nAUI TBD Closure

ryan.latchman@gennum.com

Figure YYY

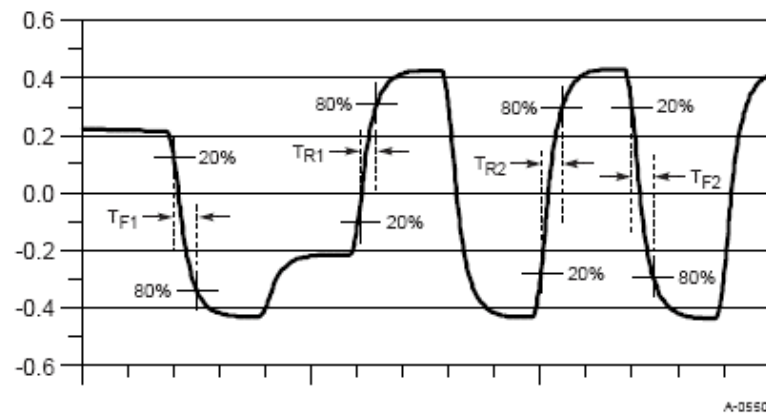
- Rise and fall times are measured from the 20% to the 80% levels of the differential voltage level. Note that, with de-emphasis, the voltage thresholds corresponding to 20% and 80% vary depending on the voltage level of the previous UI. Only those transitions crossing the zero threshold need to meet TR/TF limits defined in Table 83A-1. In Figure YYY, there are three distinct thresholds corresponding to deemphasized transitions from high to low, low to high, and full swing transitions in either direction. Rise / Fall Time must be validated for all four possible cases.

Figure 83A-3 Update

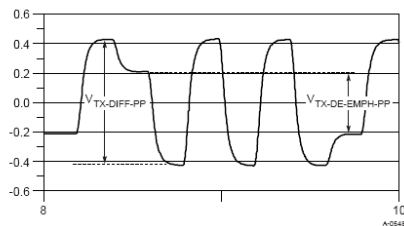
- Add row to Transmitter Characteristics Table 83A-1

Parameter	Value	Units
Minimum De-emphasis	3.5	dB

- 83A.3.3.1 Output amplitude Text:
- Driver differential output amplitude **including transmit equalization shall be less than Y2 and greater than Y1 as defined in 83A-1**. DC referenced logic levels are not defined since the receiver is AC-coupled. Single-ended output voltage range shall be between -0.4 V and 4.0 V with respect to ground.
- **De-emphasis shall be the ratio between the amplitude following a transition and the amplitude during a non-transition bit as seen in equation EEE. Amplitude measurements are taken using an averaged waveform and taken at the center of the respective UI.**
- See Figure 83A–3 for an illustration of absolute driver output voltage limits, definition of differential peak-to-peak amplitude, and definition of pre-emphasis.

$$V_{\text{TX-DE-RATIO}} = -20 \log_{10} \left(\frac{V_{\text{TX-DIFF-PP}}}{V_{\text{TX-DE-EMPH-PP}}} \right) \quad \text{Equation EEE}$$

Figure ZZZ

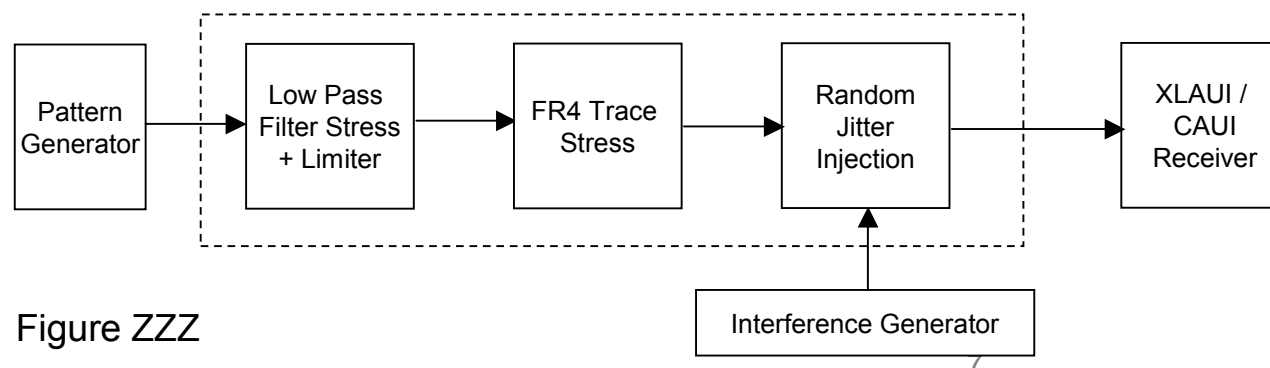
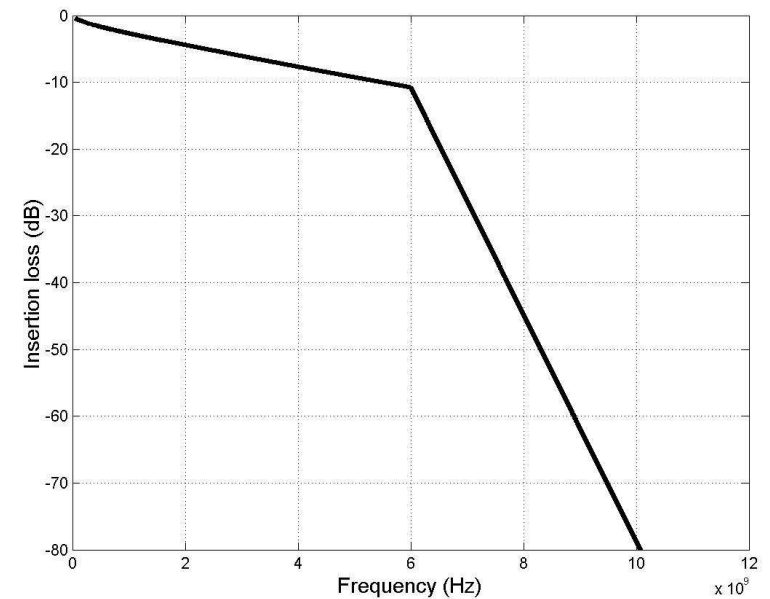
- **83A.5.2.2 Jitter Tolerance (Test Requirements)**
- **XLAUI / CAUI Jitter tolerance evaluation shall be conducted with a stressed input signal which is comprised of at least 0.42Upp deterministic jitter, and 0.2Upp random jitter. Deterministic jitter is added to a clean test pattern by adding sinusoidal jitter as defined in 83A.3.4.8, along with low pass filter stress, followed by a limiting function, and FR4 trace stress. The low pass filter stress is added until the 0.32Upp deterministic jitter is achieved. FR4 trace stress is then added until 0.42Upp deterministic jitter is achieved. Random jitter is added to the test signal using a interference generator which is a broadband noise source capable of producing white Gaussian noise with adjustable amplitude. The power spectral density shall be flat to ± 3 dB from 50MHz to 6GHz with a crest factor of no less than 5. Figure ZZZ depicts the XLAUI / CAUI Jitter Tolerance test setup. The amplitude and output jitter of the filter stress + Limiter and Random Jitter Injection shall meet the minimum receiver eye mask defined in 83A-2. All XLAUI / CAUI Channels shall be active during jitter tolerance testing**
